Virgil C. Summer Nuclear Station (VCSNS) Units 2 and 3
Combined License Nos. NPF-93 and NPF-94
Docket Nos. 52-027 & 52-028

Subject: VCSNS Units 2 & 3 LAR 14-14 R1: Revision 1 to Request for License
Amendment: Structural Design of Auxiliary Building Floors

Request for License Amendment:
Structural Design of Auxiliary Building Floors
(LAR 14-14 R1)

UFSAR Figure 3H.5-9 (Sheet 2 of 3), Auxiliary Building Finned Floor – Revise the information to add the Notes shown below.

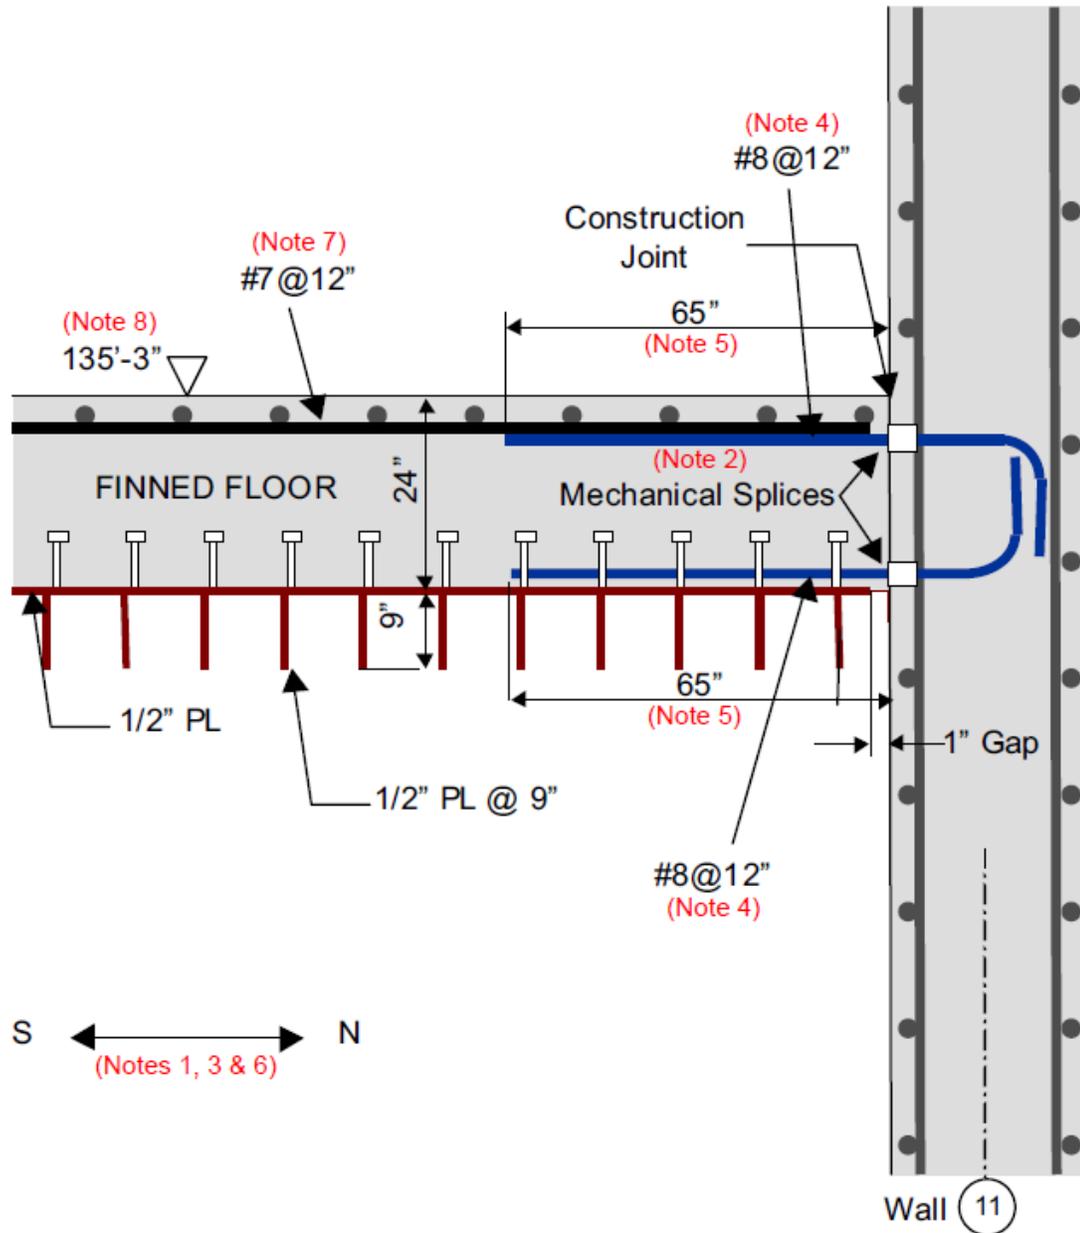
Proposed design changes are identified to the detail reinforcement design of the floor to wall connection represented in UFSAR Figure 3H.5-9, Sheet 2. The figure shows a floor to wall connection including reinforcement dowels connected to the wall and studs attached to the steel plate on the bottom of the floor. The figure identifies a length for the dowel for the critical section. The dowel length used for the critical section is not used for floors at or near the 82'-6" and 92'-6" design elevation in the south end of the auxiliary building.

On UFSAR Figure 3H.5-9, Sheet 2, a note (4) is added to address the range of size and spacing of the connecting dowel, and a note (5) is added to address variation in the length dimension of the reinforcement bar dowel. This activity does not change the design basis or design methodology for the connection between the floor and wall. The connection design was approved as part of the AP1000 design as represented in UFSAR Figure 3H.5-9, Sheet 2. However, the details of the design methodology and design basis of the connection are not specified or discussed in the UFSAR. These details are added as notes on the figure addressing splice length criteria and stud sizing and spacing, and a supplemental evaluation was conducted to document the basis for the connection design and methodology. These notes are applicable to selected floors at or near the 82'-6" and 92'-6" design elevation in the south end of the auxiliary building. The supplemental evaluation demonstrates in detail that the force transfer in the connection design satisfies the ACI 349 and AISC N690 code requirements and appropriately transfers the loads through the connection. Therefore, the supplemental evaluation demonstrates the applicability of the ACI 349 and AISC N690 code requirements. Note 4 also allows for variation in the size and spacing of the lower dowels to optimize construction.

A note (6) is added to allow for the construction joint shown between the floor and wall and the gap between the steel plate and the wall to vary because these elements may vary based on fabrication considerations and construction sequence.

- K. Revise UFSAR Figure 3H.5-9, Sheet 2, as follows: (Change Activities 1 and 5):
 - 1. Through 8. Not used.
 - 9. Add notes to the figure to provide the following information: These notes are applicable to CA20 floors at or near the 82'-6" and 92'-6" design elevation in the auxiliary building.

- a. State that the section shown is a specific location and other locations will have variations in design details.
 - b. State that headed reinforcement may be used.

- c. Identify the requirements for development of headed reinforcement.

- d. Identify the code requirements for reinforcement size and spacing and provide the range of reinforcement size and spacing.
 - e. Identify the requirements for dowel length.
 - f. Allow for variation in use of construction joint, gap between steel plate and wall and use of mechanical couplers in lieu of mechanical splices based on fabrication and construction needs.
 - g. State that the reinforcement shown is for locations away from obstructions.
 - h. State that the elevation of the top of concrete is based on location and design requirements for the floors.
- L. Revise UFSAR Figure 3H.5-9, Sheet 3, as follows: (Change Activity 1):
- 1. Add note to the figure to provide the following information:
 - a. State that the shear stud design shown is for locations away from obstructions.

Proposed changes are identified for the development of the reinforcement in the floor and for the detail design of the connection of the floor to the wall to be consistent with standard construction practice. These changes are included in the revised UFSAR Figure 3H.5-9, Sheet 2. A note (6) allows for "Mechanical Splices" to be replaced with "Mechanical Couplers," and for the gap between the steel plate and wall and use of a construction joint to vary because these are related to fabrication details and construction sequence. These changes do not affect the strength of the floor or connections or the conformance with ACI 349 and AISC N690.

A note is added to allow for different lengths for the reinforcement bar dowels in UFSAR Figure 3H.5-9 because the ACI code requires different lengths based on the reinforcement size used for other sections. Also, the length of the dowels must be sufficient to incorporate sufficient shear studs to develop the capacity of the dowels and the demand in the bottom plate. The design of the connection satisfies the requirements in ACI 349, Appendix B, for strength of the shear studs, and AISC N690 for shear stud capacity. ACI 349, Appendix B includes requirements for shear studs used as anchors in concrete. These requirements are used to determine the strength of the shear studs and the connection to the bottom plate to determine the number of shear studs required within the dowel length. Information is added in the notes on the figure about the ACI 349 and AISC N690 requirements for the length of the reinforcement dowels. These notes are applicable to selected floors at or near the 82'-6" and 92'-6" design elevation in the south end of the auxiliary building. Specifying additional details on the use of the code requirements for the connection design does not change the design basis of the

NOTES APPLICABLE TO CA20 MODULE FLOORS AT EL. 82'-6" and EL. 92'-6":

1. DETAIL SHOWN IS SPECIFIC TO THE REINFORCED CONCRETE FLOOR AT EL. 135'-3" (MAIN CONTROL ROOM CEILING). REFER TO THIS AND OTHER NOTES FOR ADDITIONAL INFORMATION ABOUT DESIGN DETAILS FOR OTHER FLOOR SECTIONS AND FOR CONNECTIONS TO WALLS OTHER THAN THE WALL ALONG COLUMN LINE 11.

2. THE DEVELOPMENT OF THE FLOOR REINFORCEMENT IN THE WALLS CAN BE HEADED REINFORCEMENT INSTEAD OF STANDARD HOOKS.
3. REFER TO SUBSECTION 3.8.4.4.1 FOR THE REQUIREMENTS FOR DEVELOPMENT OF HEADED REINFORCEMENT.

4. REINFORCEMENT SIZE AND SPACING FOR CONNECTING DOWELS ARE BASED ON THE REQUIREMENTS IN ACI 349 AND ACI 318-11, SECTION 12.6. THE RANGE OF SPACING AND SIZE OF THE CONNECTING DOWELS VARIES FROM 6" TO 12" AND FROM #8 TO #11, RESPECTIVELY.

5. SPLICE LENGTH IS THE LONGEST OF A) ACI 349 REQUIREMENTS FOR SPLICE LENGTH, B) LENGTH TO INCORPORATE SUFFICIENT SHEAR STUDS TO DEVELOP THE CAPACITY OF THE DOWEL, PER AISC N690 SHEAR STUD CAPACITIES, OR C) LENGTH TO INCORPORATE SUFFICIENT SHEAR STUDS TO DEVELOP THE DEMAND IN THE BOTTOM PLATE, PER AISC N690 SHEAR STUD CAPACITIES.

6. THE GAP BETWEEN STEEL PLATE AND WALL, USE OF CONSTRUCTION JOINTS, AND USE OF MECHANICAL COUPLERS IN LIEU OF MECHANICAL SPLICES VARIES BASED ON FABRICATION AND CONSTRUCTION NEEDS.

7. THE REINFORCEMENT SHOWN IS FOR LOCATIONS AWAY FROM OPENINGS, PENETRATIONS, EMBEDMENTS, AND OTHER OBSTRUCTIONS. THE RANGE OF REINFORCEMENT SIZE AND SPACING VARIES FROM #8 TO #11 AND FROM 6" TO 12", RESPECTIVELY

8. THE ELEVATION OF THE TOP OF CONCRETE IS BASED ON LOCATION AND DESIGN REQUIREMENTS FOR THE FLOORS.
